## **Cory Decarbonisation Project**

### **Written Representation on behalf of Landsul Limited and Munster Joinery (U.K.) Limited**

Figure 1 – Indicative Equipment Layout from DCO

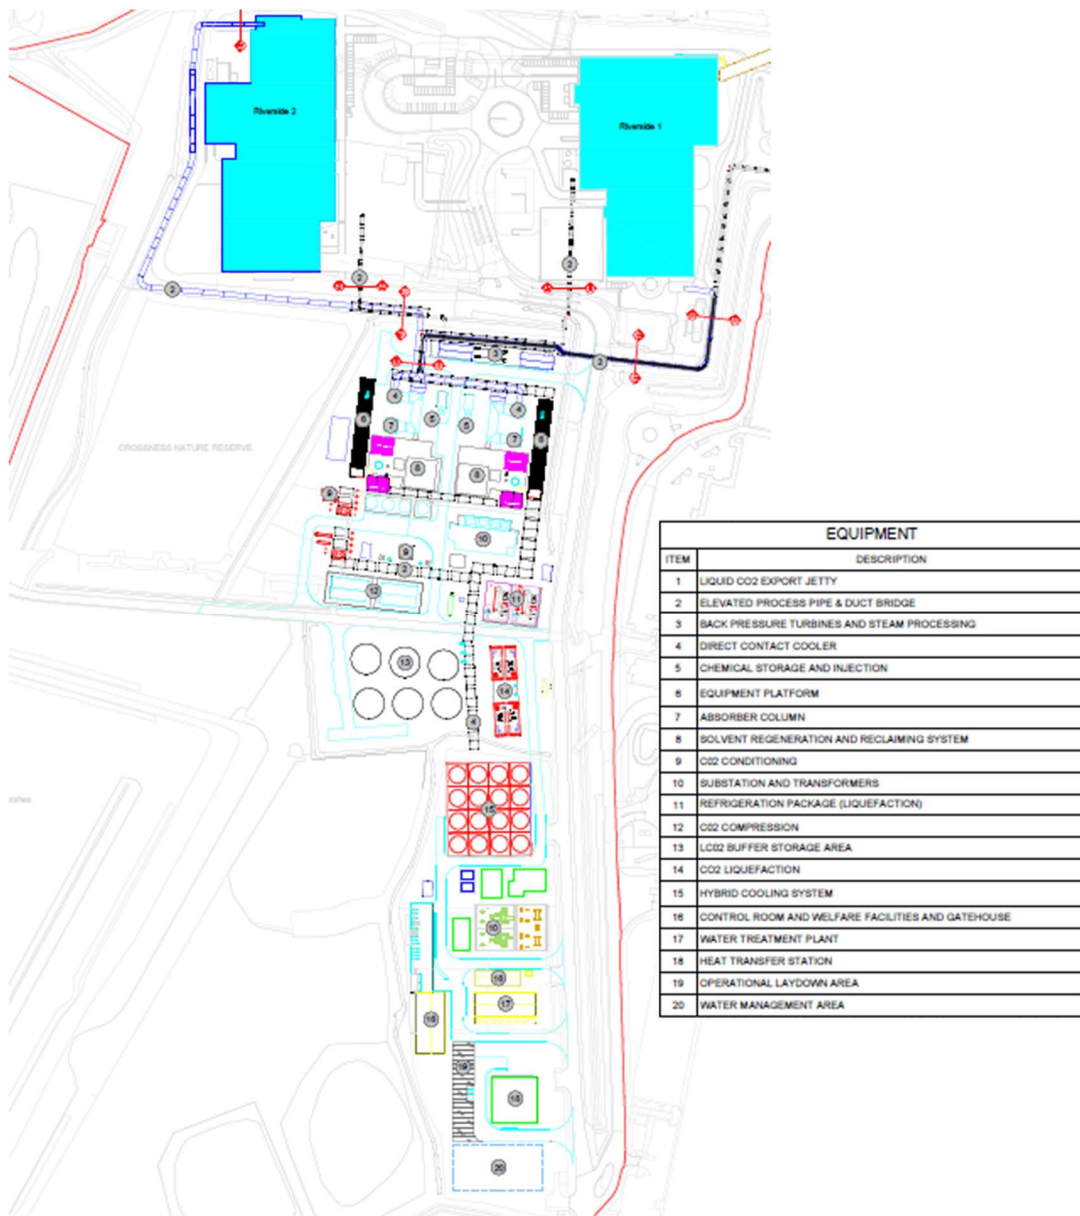
2.6 The equipment selected is generally typical of what would be expected for a facility to capture, liquefy and store CO<sub>2</sub>. However, as I will explain in the following sections, there are some items of equipment that appear unnecessary and this, combined with some of the design assumptions, has led to a site footprint that is considerably larger than required.

2.23 In terms of the footprint occupied by this plant (items 3 to 8 in Figure 1) it is broadly in-line with what I would expect for a 2-line plant of this capacity.

Figure 2 - Footprint comparison (2 line vs 1 line)

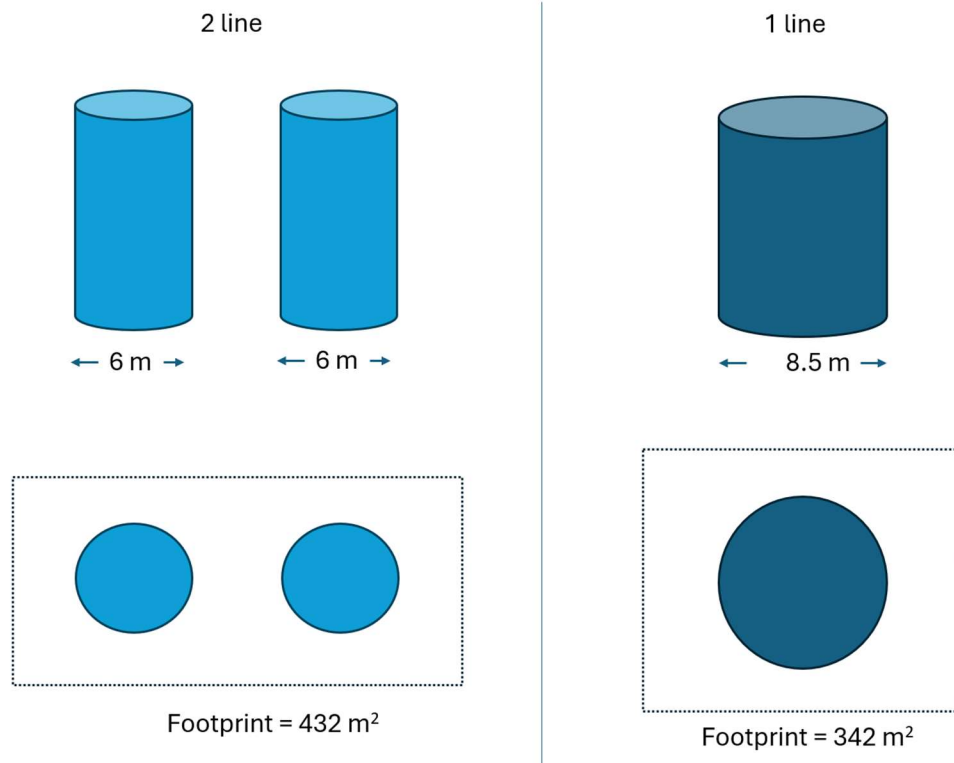
2.14 Finally, and most significantly, the overall site footprint is dictated not just by the process equipment itself but the need to provide access for operation and maintenance. Therefore, doubling the quantity of equipment also significantly increases the space that is required to permit operation and maintenance. This is illustrated by the simple sketch below which shows a 2 line plant utilising 2 x 6m diameter columns and the equivalent 1 line plant which would require a 8.5m diameter column to maintain the same column cross sectional area. For the sake of illustration, I have kept the height the same although (as per paragraph 2.13) this is not a hard constraint. For both, a 5m buffer around the units has been provided for maintenance. It can be seen that the footprint for the 1 line plant is 342 m<sup>2</sup> whilst the footprint for the 2 line plant is 432 m<sup>2</sup> (26% more).

2.15 It can be seen that the decision to adopt a two-line approach is not neutral in terms of footprint as the Applicant suggests. Rather, selecting a two-line approach will significantly increase the required footprint.

Figure 3 - "Substation and Transformers" equipment item from DCO application

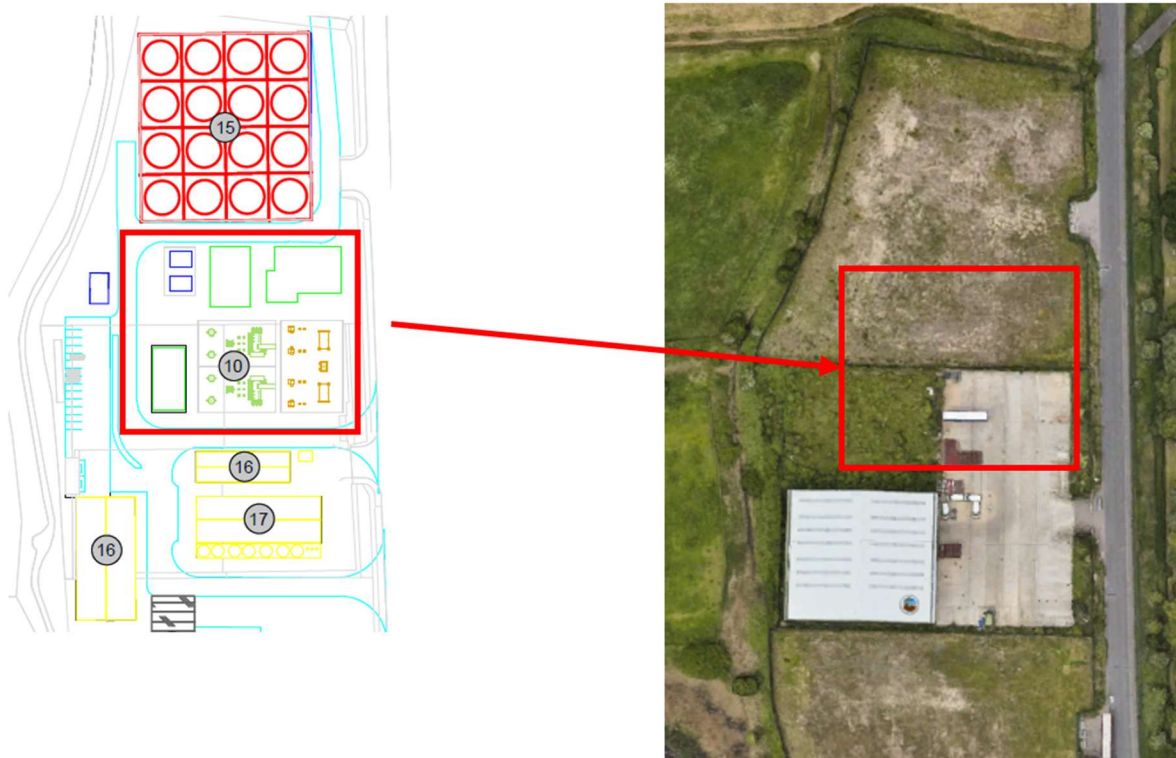
2.19 However, despite these arrangements the Applicant has also included a separate switchyard (item 10). This is shown in the diagram along with the approximate location on a satellite image from Google Earth.

2.20 Substation and transformer plant is used to provide appropriate isolations, metering and voltage step-up / step-down to connect facilities to electricity supplies on distribution and transmission electrical networks. In short, they enable electricity to be either imported or exported from a site. However, given that the Applicant proposes to serve the electrical needs of the development through a connection to the existing Riverside 1 and 2 facilities plus self-generation through a back-pressure steam turbine generator unit the need for this substation and transformer plant is not apparent.

2.21 The area of the red box in figure 3 is approximately 0.4 hectares (4,000 m<sup>2</sup>). This is equivalent to about half of the Munster Joinery Land.

Figure 5 - Liquefaction and Storage (items 11, 13 and 14)

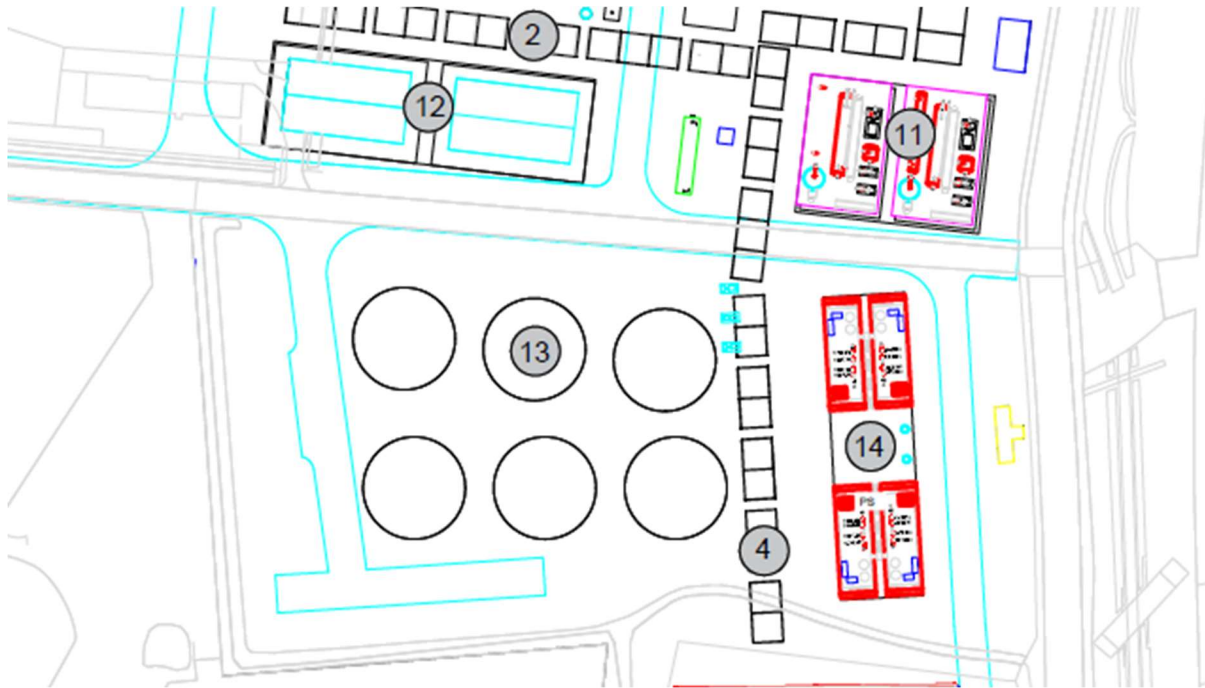
- 2.28 The area of land occupied by the liquefaction and storage is approximately 11,250 m<sup>2</sup>. However, it can be seen from Figure 5 that the actual process equipment occupies less than half of this. As I discuss in 3.8 to 3.9 it is possible to accommodate liquefaction and storage equipment that will achieve the required duty in a much reduced space without compromising operability and maintainability.

- 2.35 My own assessment of the storage requirements is that the same volume of storage can be provided in less space than the Applicant has allowed. In particular, the Applicant’s layout shows 6 storage spheres but I consider that only 3 storage spheres are required to provide approximately 24,000 m<sup>3</sup> of CO<sub>2</sub> storage.

Figure 6- Heat transfer station and operational laydown area

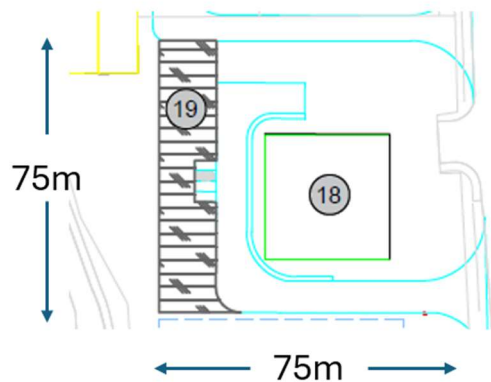
- 2.48 A feature of the Applicant’s layout is the significant space that is allowed around items of equipment and a failure to best optimise the footprint available. The heat transfer station is an example of this as can be seen from Figure 6 below. The heat transfer station is designated 18 whilst area 19 is designated for operational laydown. It can be seen that the heat transfer station is surrounded by roads and hardstanding meaning that the building itself occupies only about 25% of the available area to the east of the operational laydown area. Access to the operational laydown area is achieved from a road running between that area and the heat transfer station ignoring the potential to use the area to the west of the operational laydown area for access which means that area is effectively unused.

- 2.49 As shown in Figure 6 the Applicant has configured the site such that there is an area allocated for operational laydown. Operational laydown, in relatively close proximity to the plant is certainly beneficial – particularly during outages. However, there is no absolute requirement that this be on the carbon capture site itself – it could be located within the wider Riverside campus. It would appear that there is plenty of other alternative land available to the Applicant for temporary laydown on the existing EfW facilities as shown in the image from Google Earth below.

Figure 11 - Options considered by the Applicant

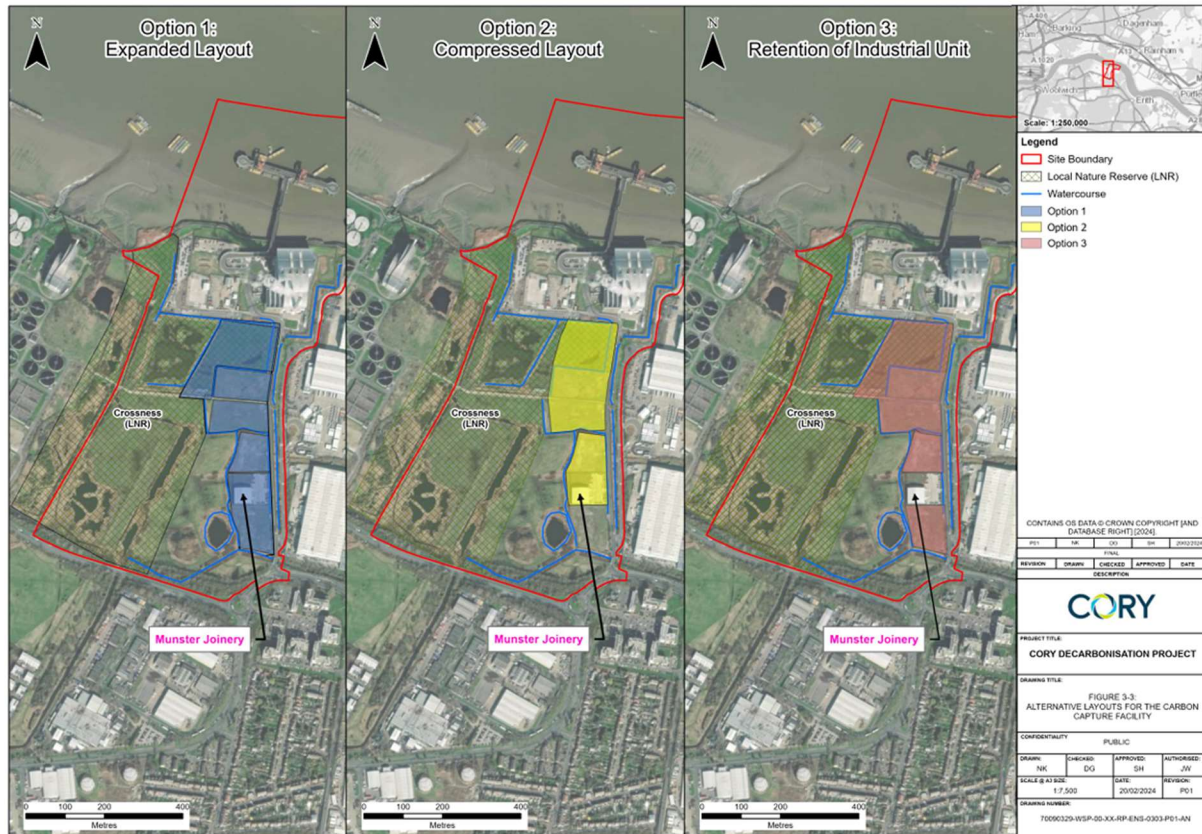
4.2 The Applicant states the required footprint to be approximately 8 hectares (80,000 m<sup>2</sup>)<sup>[16]</sup>. As shown in Figure 11 the Applicant provides a footprint<sup>[19]</sup> for three different potential layouts.

4.3 As a comparison, I have measured the total footprints of the Applicant’s options and my alternative layout using Google Earth. The comparative approximate footprints are:

Figure 17- North 1 Zone available footprint

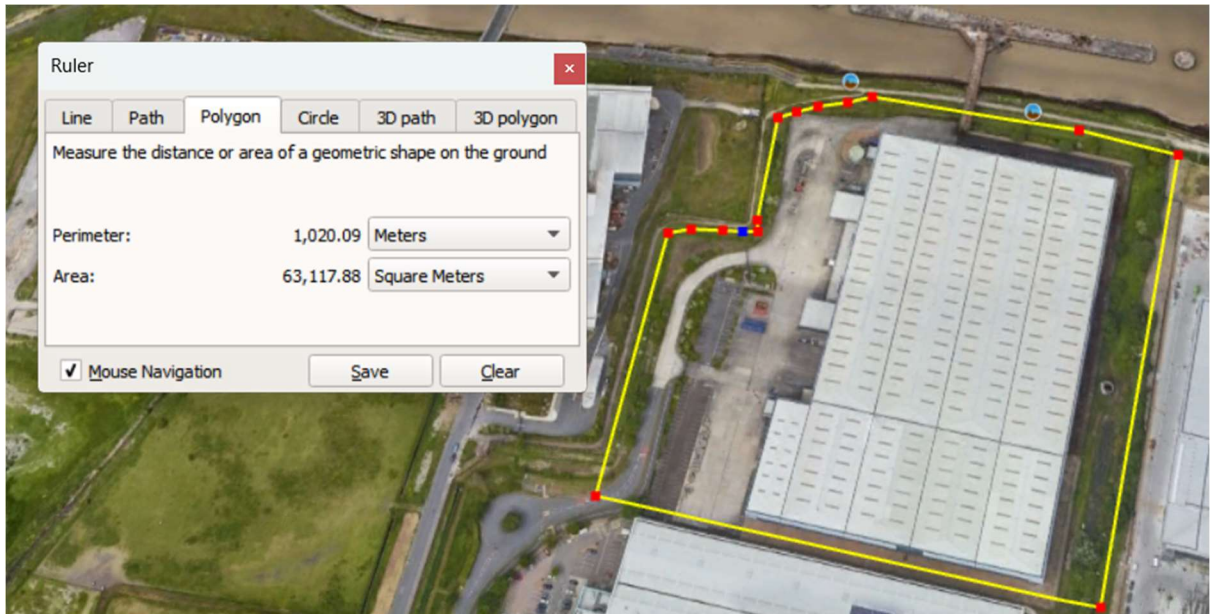
- 4.18 I would also note that in terms of business impact, the area that is actually required for the development is very much smaller than the East zone considered. As shown in Figure 17 below, the terrestrial part of the area now designated as North 1 by the Applicant is sufficiently large to accommodate the full carbon capture development even using the 61,000 m<sup>2</sup> footprint of the Applicant’s own proposed scheme. The result of this is that there would be no impact on the Lidl operation as assumed in the assessment of the East Zone in the Terrestrial Site Alternatives Report.
